Service Letter No. EX3 August, 1994

**Subject: In-line Pump Bracket, P/N 020255, and Switch Mounting Screws,
P/N 020180**

Models Affected: EXB59 and EXC83

In-line Pump

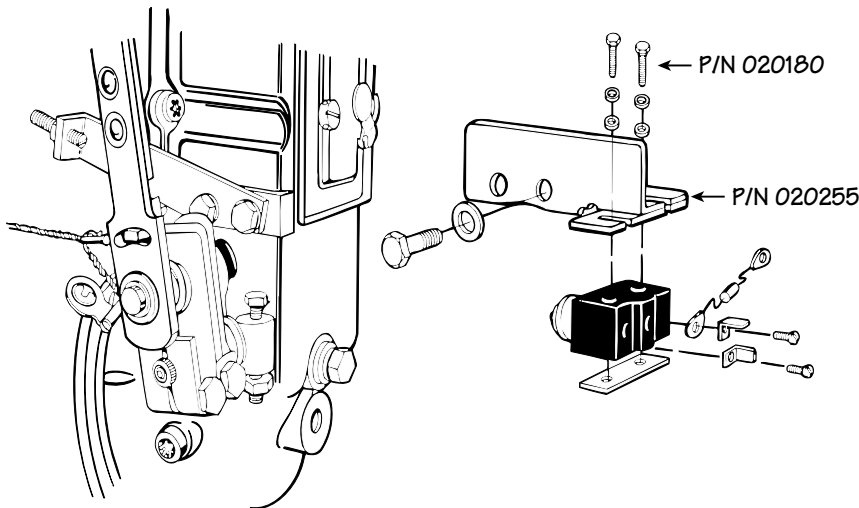
All Extarder kits containing Engine Control Groups, P/N 019429 and P/N 019598, shipped **after August 1, 1994**, will contain a new In-line Pump Bracket, P/N 020255. This bracket replaces P/N 019048 or 020149.

In addition, two (2) Hex-head Screws, P/N 020180, used to mount the switch (P/N 018188) to the new bracket have been added to the control group. This change has no effect on the mounting on the fuel pump switch arrangement to the fuel pump.

The new bracket/screw arrangement is interchangeable with the old bracket/screw arrangement.

Use the Bracket, P/N 020255, as a service replacement part for P/N 019048 or P/N 020149. Stock return of P/N 019048 and 020149 for credit will be accepted for 90 days from August 10, 1994.
